Location Address: 2027 Fletcher Street  
Lot(s): 11 Block(s): 3 Subdivision: SOUTH SIDE PARK

Explanation of Request: Developing 23- unit Multi-Family Apartments

**SUBJECT:** Preliminary Site Plan review for a 23-unit residential development. (2027 Fletcher).

5 ACCESSIBLE CURB RAMP  
NOT TO SCALE

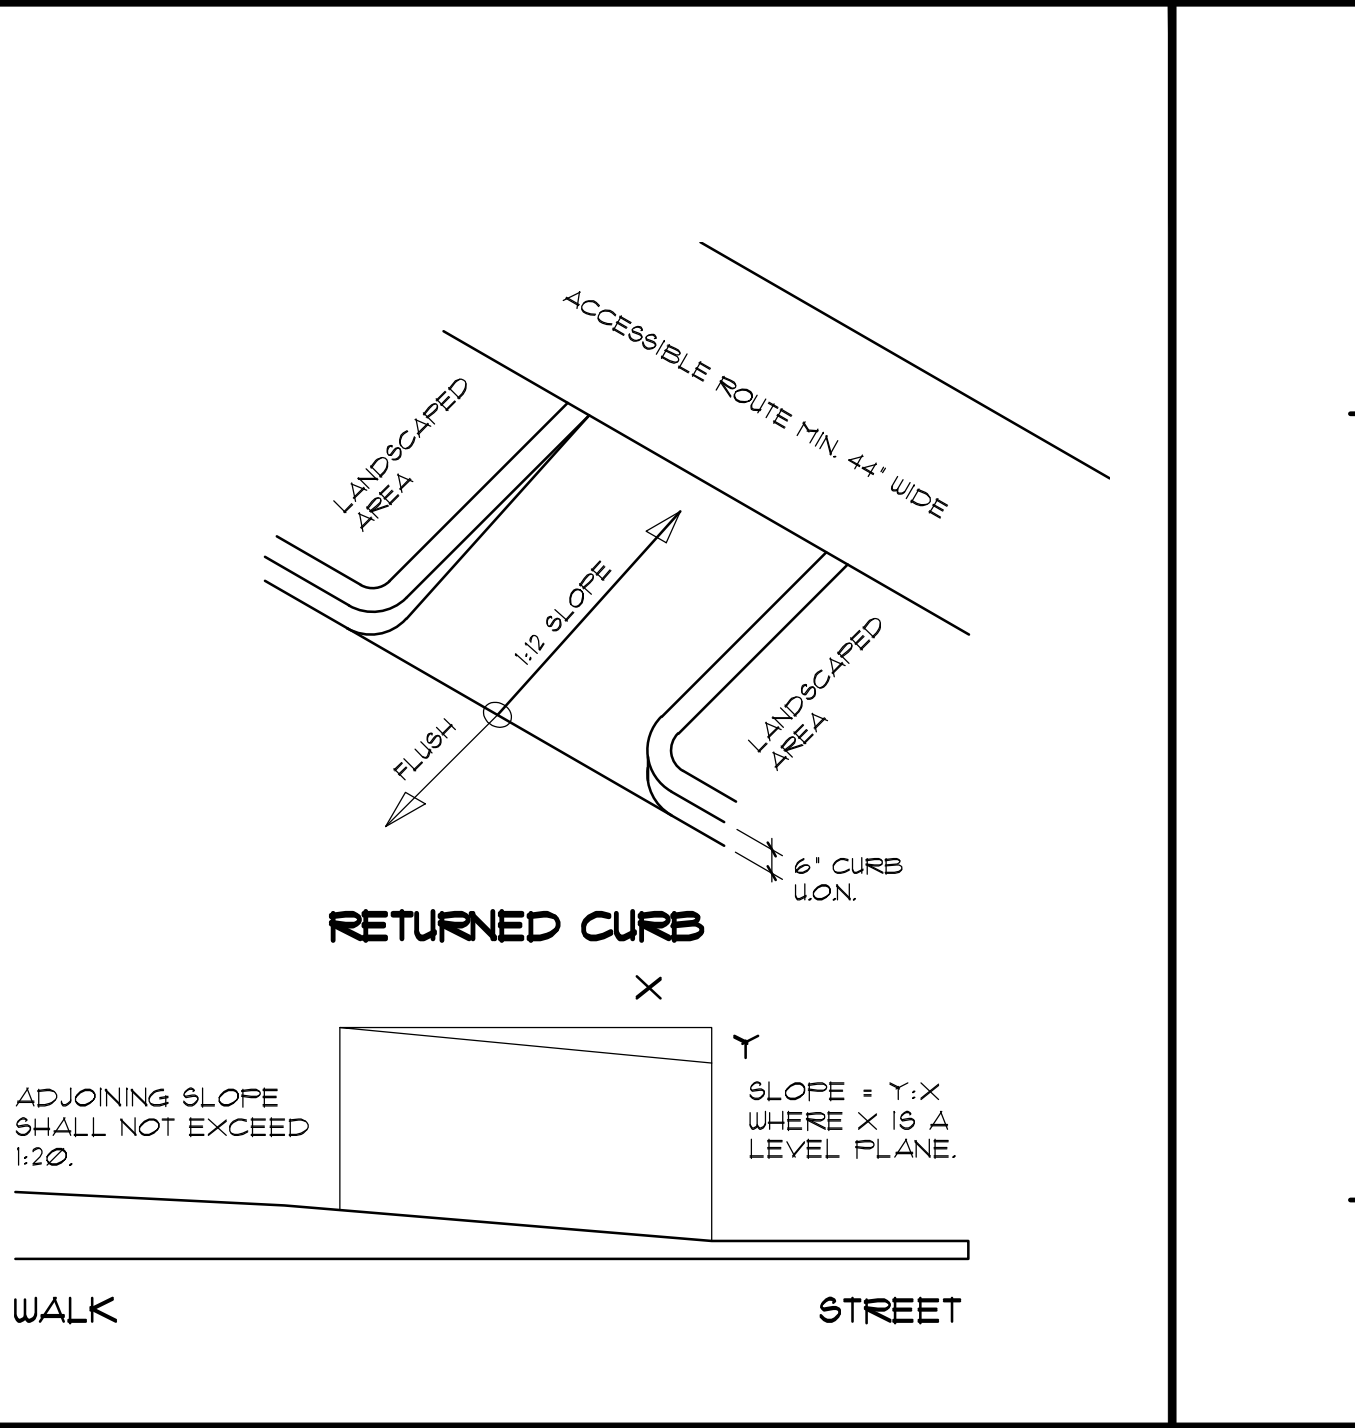
9. Provide curb ramp with detectable warnings at all accessible crossing. Provide detail for detectable warnings.

***Response: Refer to SP-1.2***

**A-1.1**  
OF SHEETS

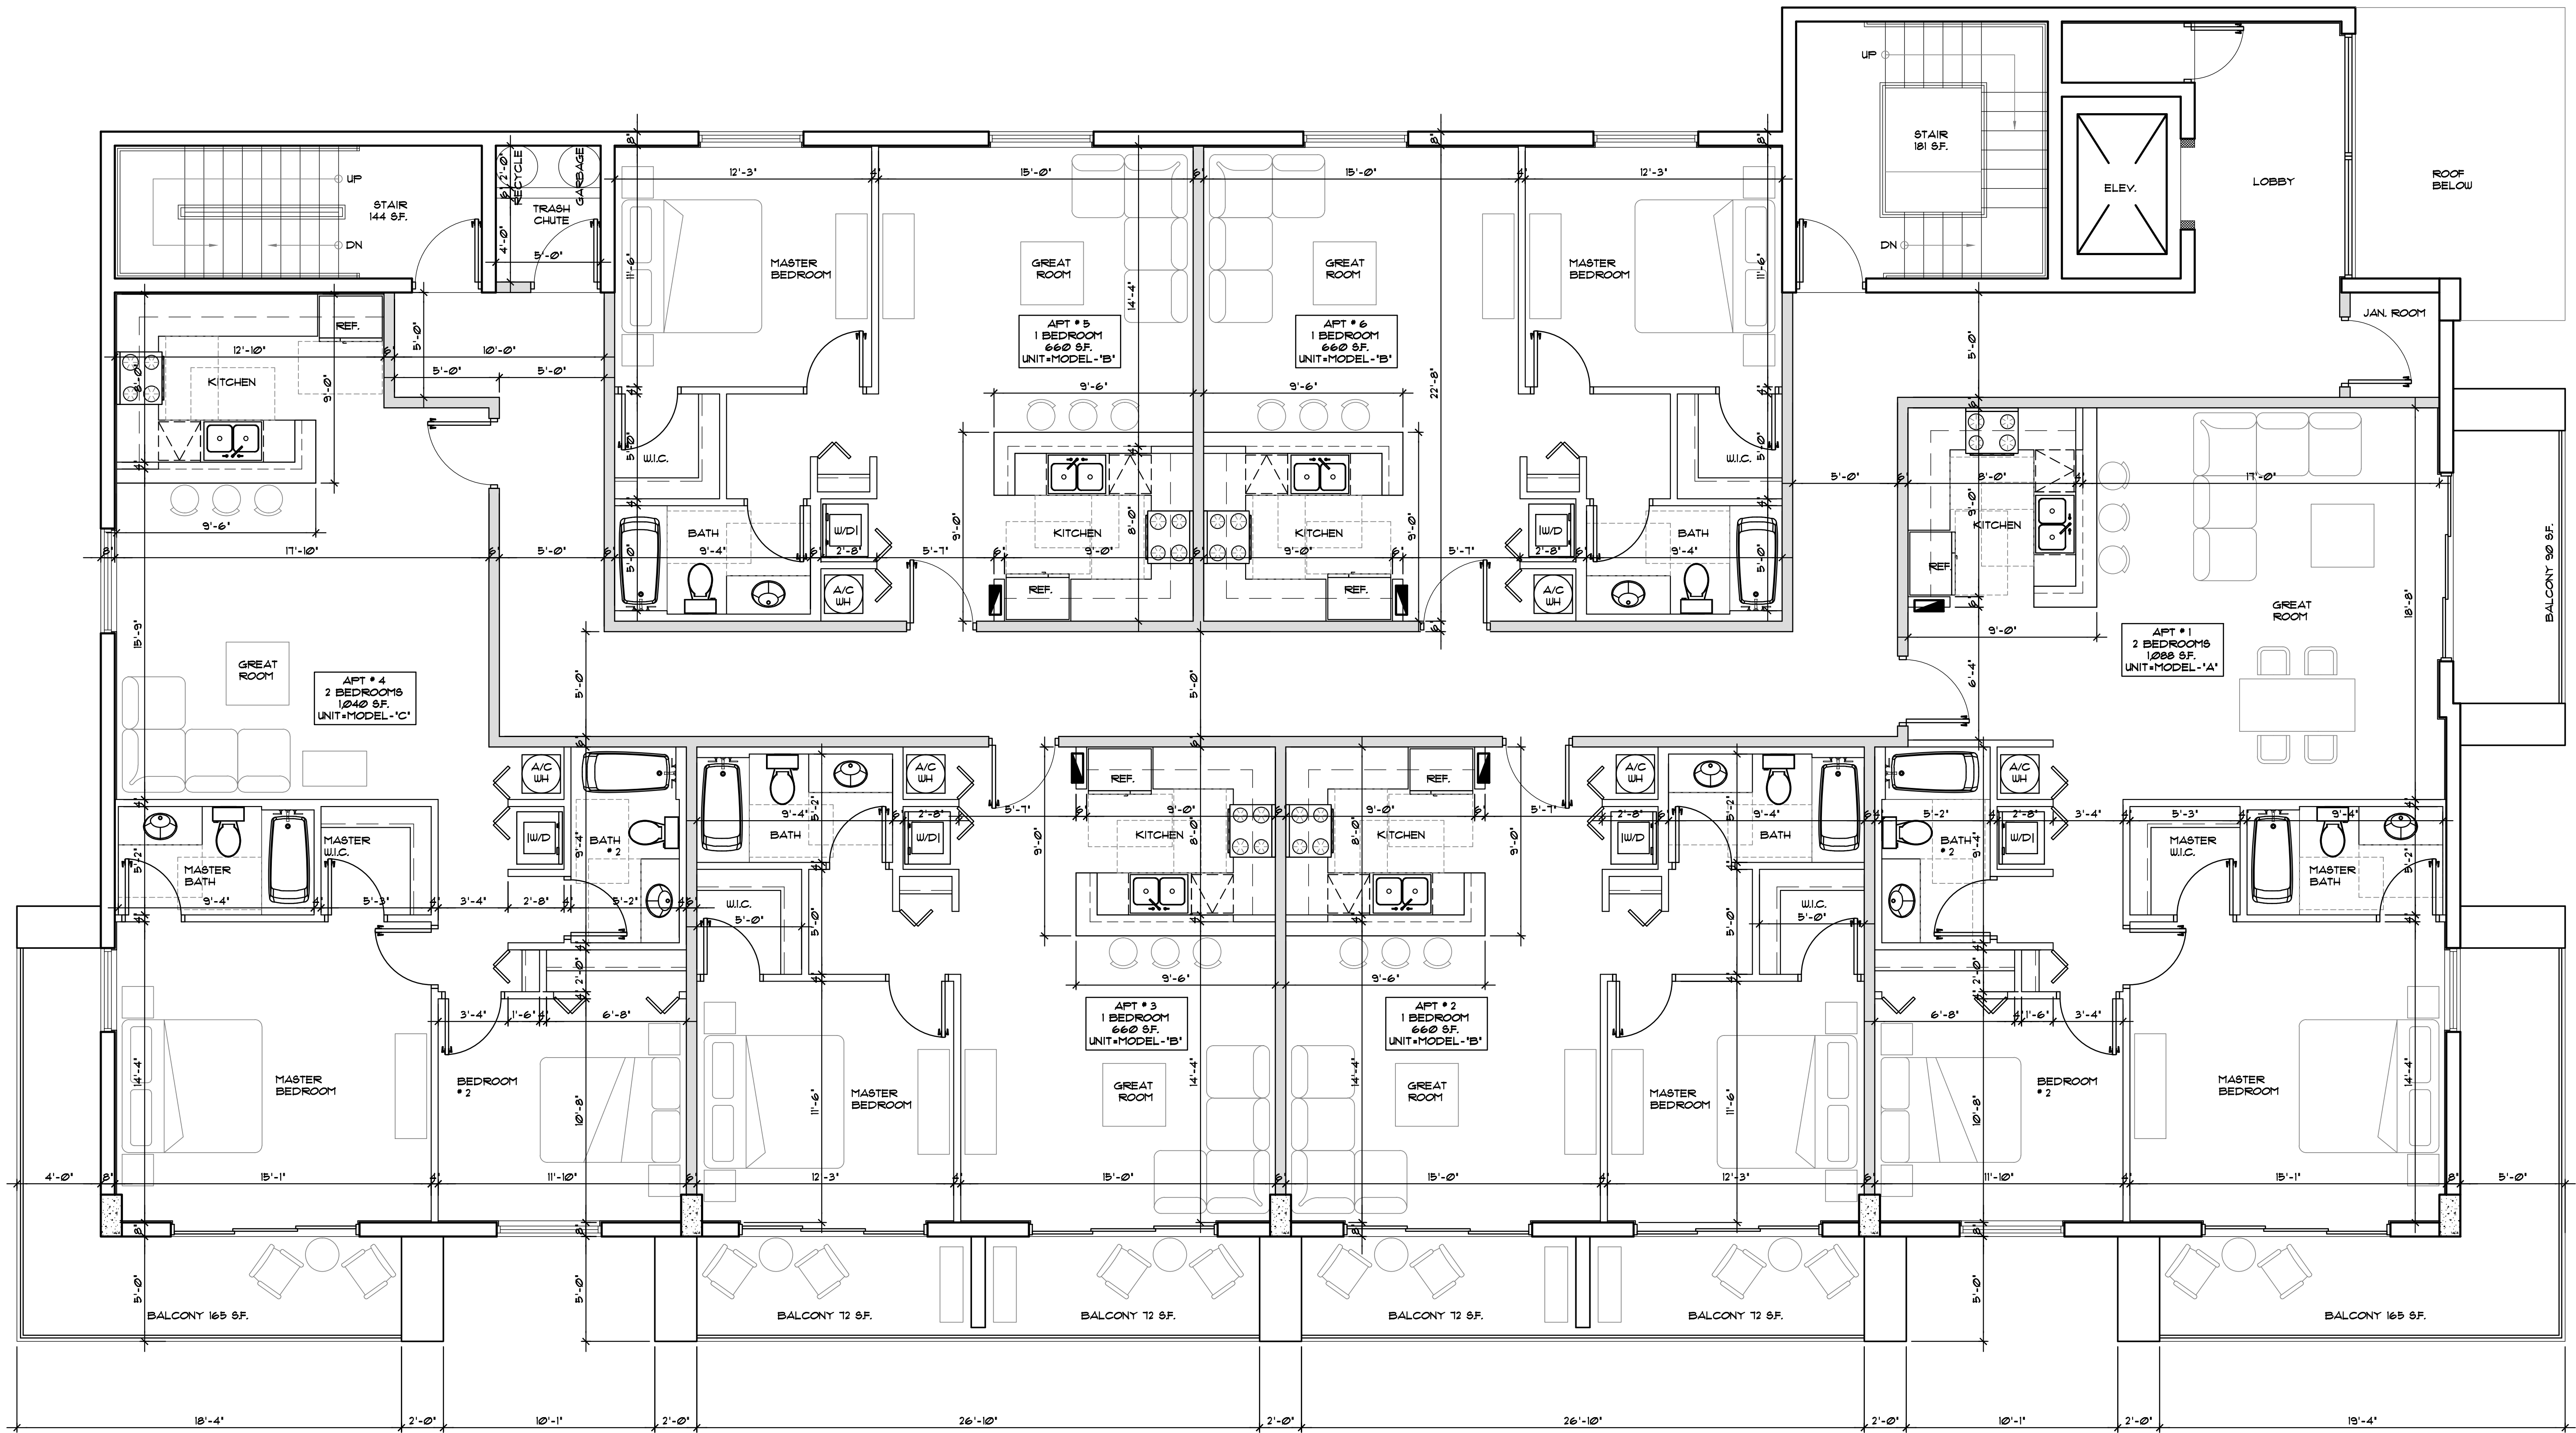
- c. Provide method of mail delivery.

2. For the parking garage, indicate location of building structural columns. Columns shall not be within 3 feet of the entrance of a parking stall. Add dimensions to your plan.

***Response: Refer to SP-1.1. and A-1.1. Shown in Lobby***

***Response: Revised Refer to SP-1.1 and A-1.1***
